CITY PLANNING COMMISSION

- APPLICATION:**
- A. Negative Declaration
 - B. Rezone 2+ acres from Single Family (R-1) to Garden Apartment (R-2B) zone
 - C. Lot Line Adjustment to combine two lots

LOCATION: 6131-6141 63rd Street

PROPOSAL: The applicant is requesting the necessary entitlements to develop a 41 unit apartment complex in the Colonial Community Plan area.

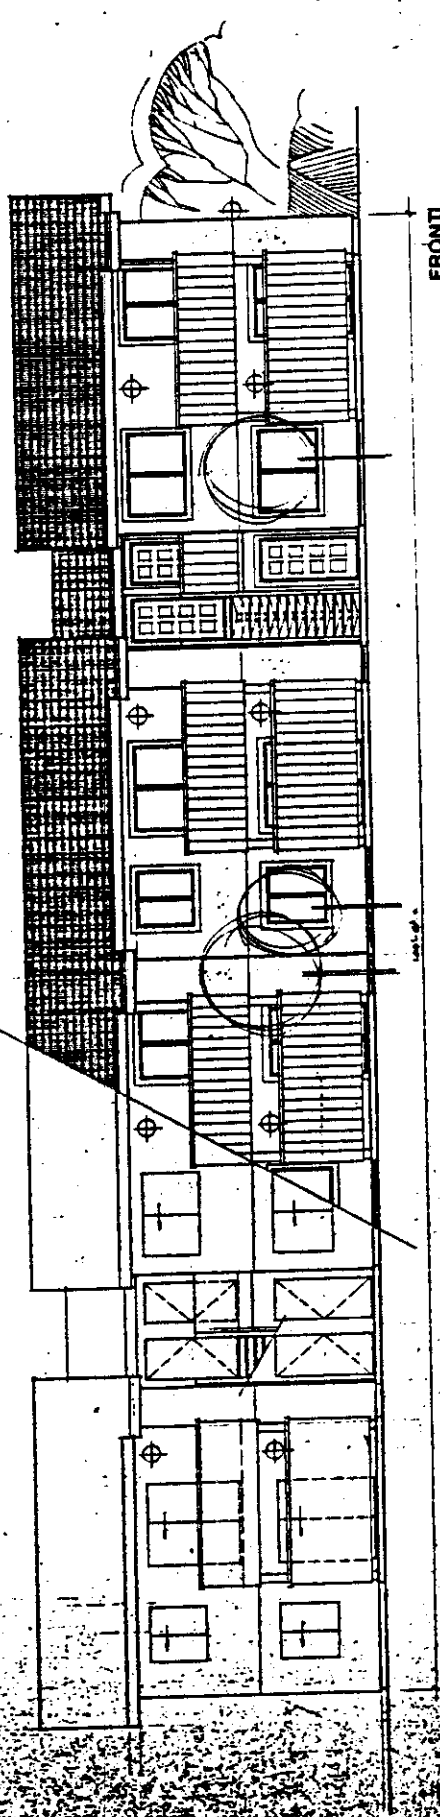
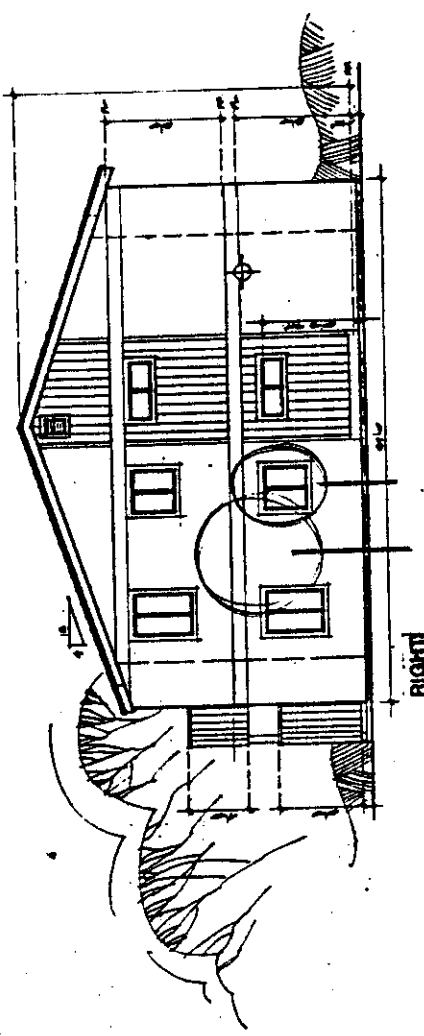
- B. Circulation: The subject site is bordered by a one acre landlocked parcel to the east. Potential access to this parcel can be provided by a 50 foot wide cul-de-sac street as shown on Exhibit D. In order to allow a portion of the cul-de-sac bulb on the subject site, the buildings located on the east half of the subject site will have to be shifted south a sufficient distance to accommodate the bulb and a 25 foot building setback from this future street. The final site plan shall be revised accordingly to accommodate this future street design.

REQUIRE 25' BLDG. SETBACK FROM FUTURE COL-DE-SAC

The location of buildings on the east half of the subject site shall be shifted south a sufficient distance to accommodate a 40 foot radius bulb as shown on Exhibit D and a 25 foot building setback from the property line of this future street.
